# **SUPPLEMENTARY REPORT**

# **ENVIRONMENTAL IMPACT STATEMENT**

## **PROPOSED WALLERAWANG QUARRY**

**Pacrim**  
ENVIRONMENTAL  
Report 02/206.1  
July 2002

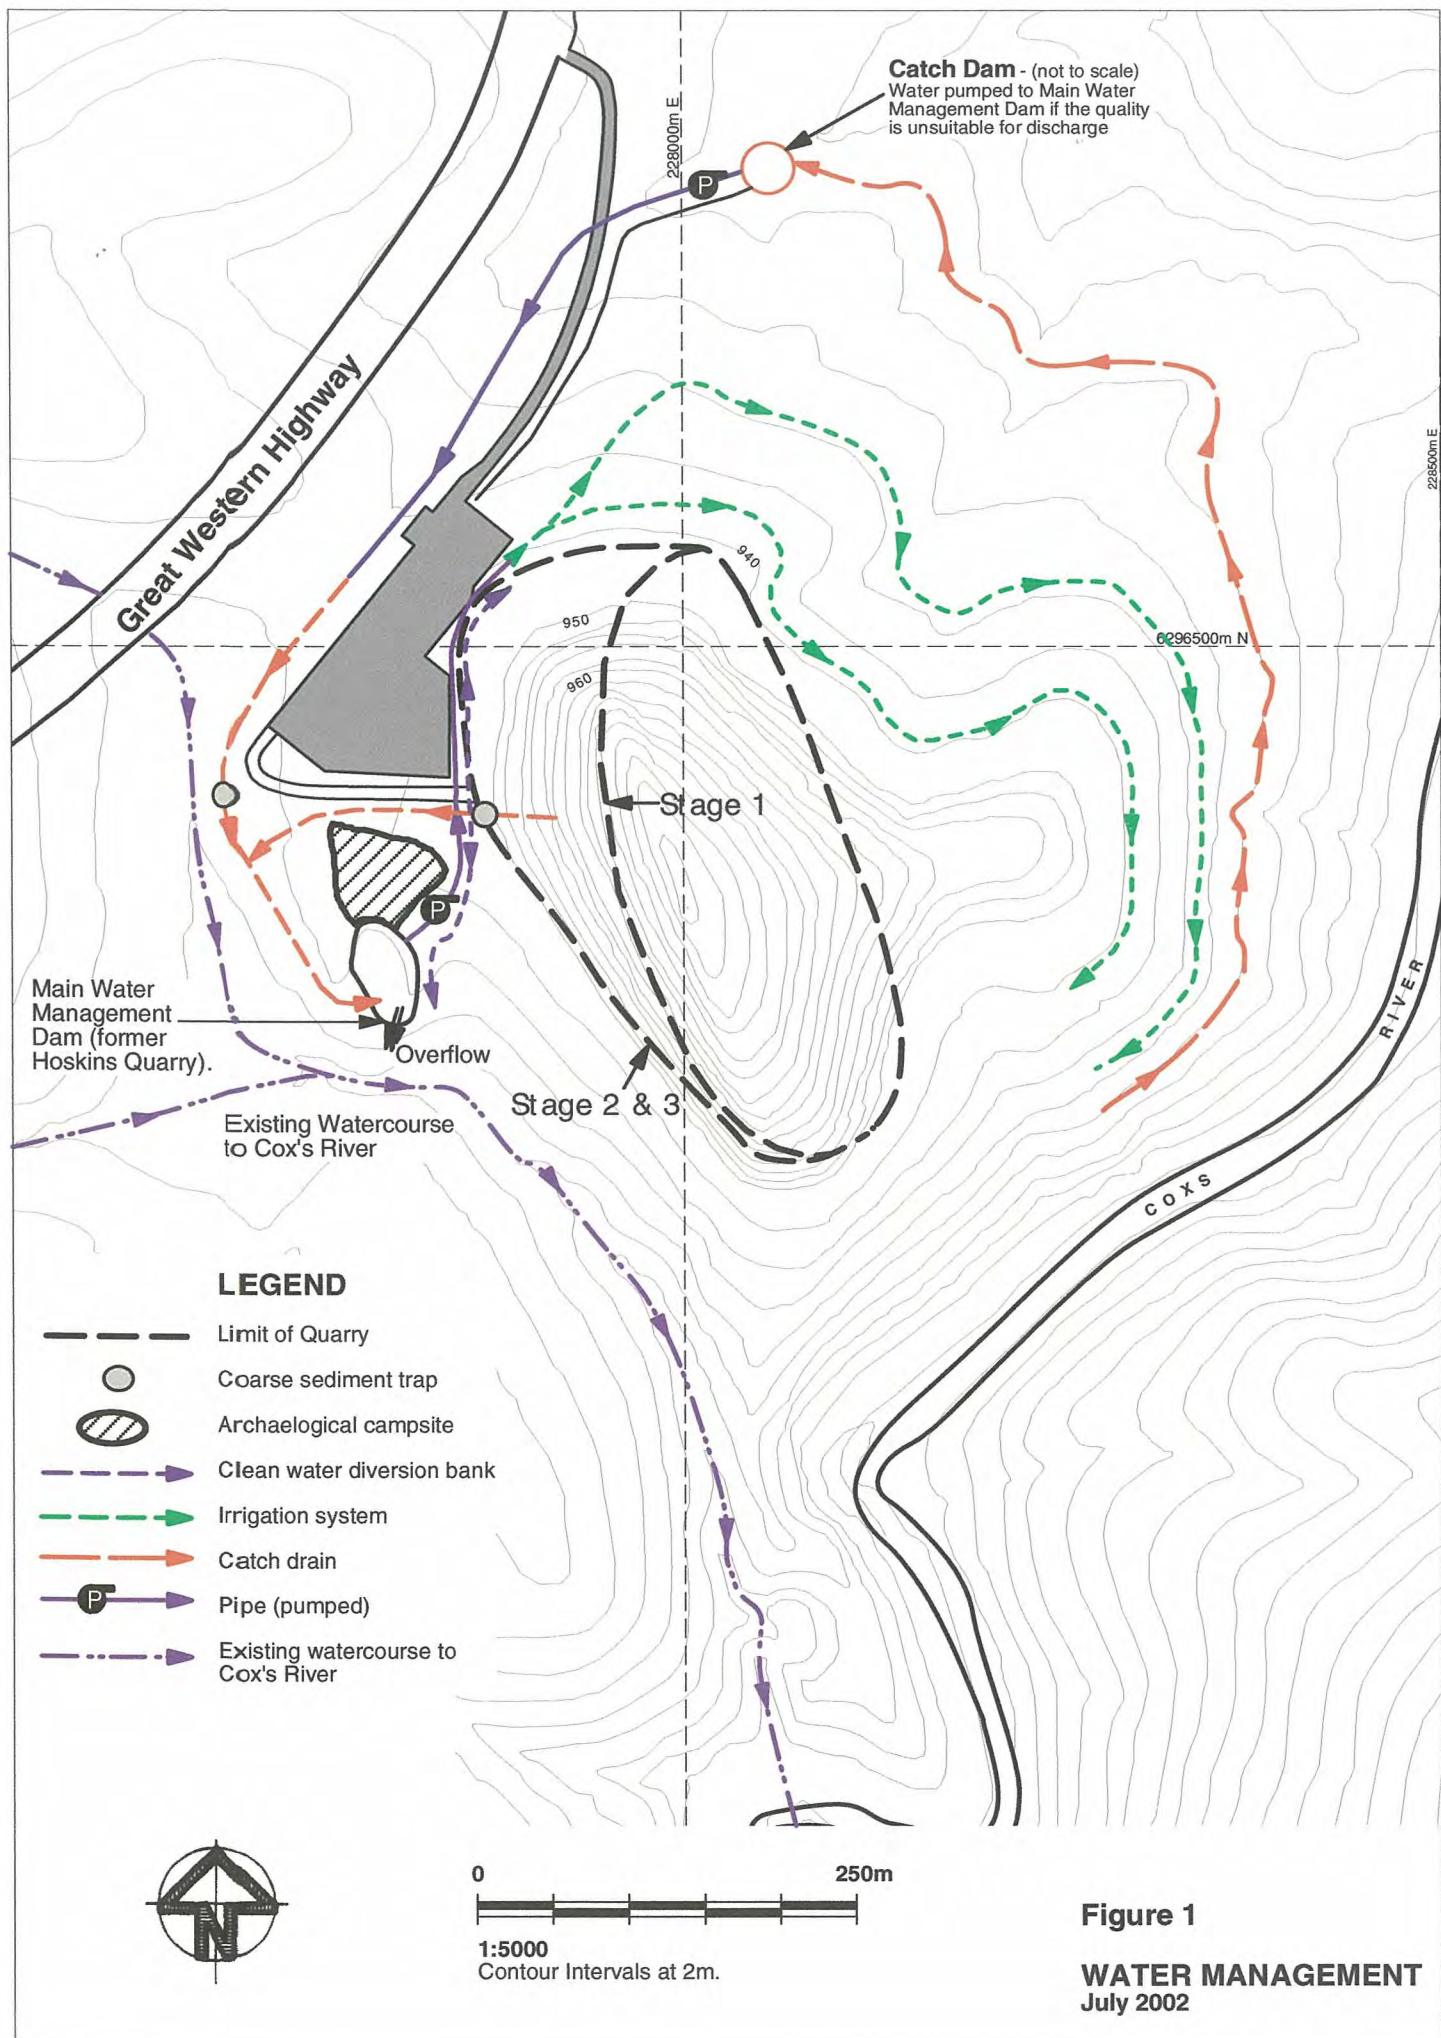
73. *Provide a clear definition of the location of water collection and storage facilities including proposed catch drains and irrigation system.*

87. *The level of detail provided regarding the layout of the water management system is particularly disappointing given that water management is one of the key environmental issues.*

Refer to Figure 1 – Water Management, attached.

Figures 4.2 and 4.3 of the EIS show two coarse sediment traps, one is located on the drainage line from the quarry area, the other is located on the drainage line which runs behind the surface facilities. These coarse sediment traps are also shown on Figure 1 in this report.

The spillway and clean water diversions are shown on Figures 4.2 and 4.3 of the EIS for Stage 1 and Stages 2 and 3 respectively. The location of these structures is also indicated on Figure 1 included in this report. All rainfall falling on undisturbed areas (ie. clean water) will be diverted from the site to natural watercourses in the area.

The layout of water management structures is shown on Figure 1 in this report. A detailed Water Management Plan will be developed for the site prior to commencement of the project, subsequent to approval of the location of surface facilities etc. This plan will show the locations of the proposed water management structures.

The inlet and outlet structures for the Main Water Management Dam are shown on Figure 1. The structures will not be located within the archaeological site.

**Figure 2**  
**Line of Sight Section A from Mt Walker Reserve.**  
 July 2002

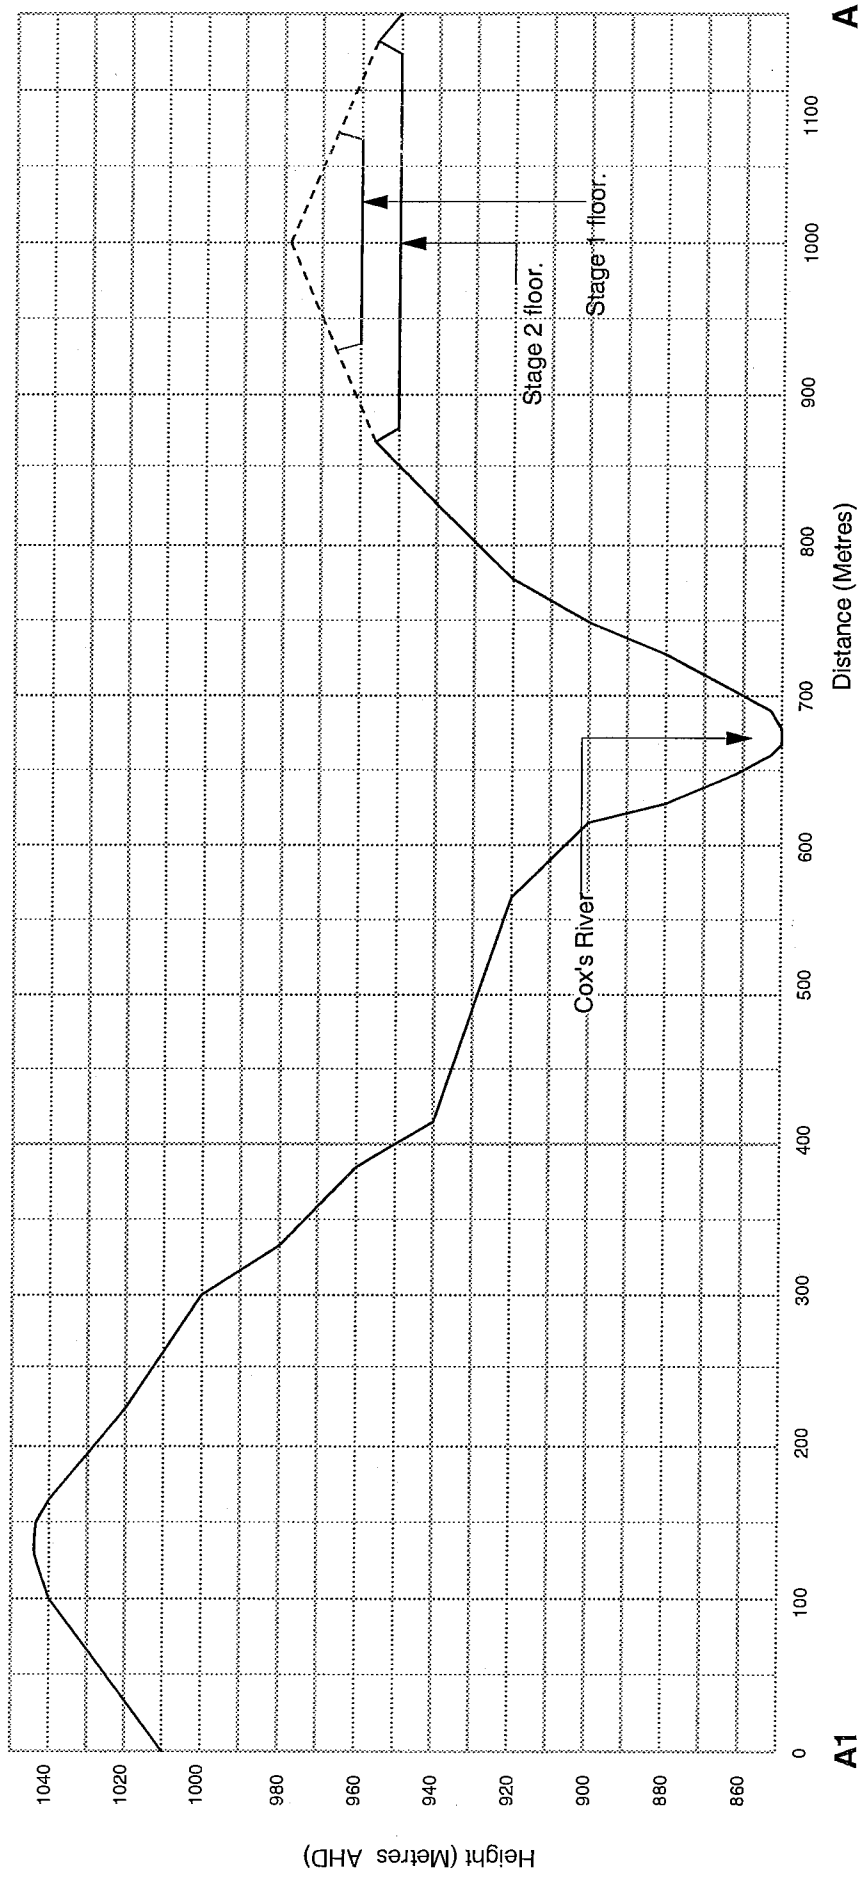
99. *The relationship, during the life of the quarry, to the nearby dwellings and the surrounding countryside is unclear. Provide a contour map showing the location of*
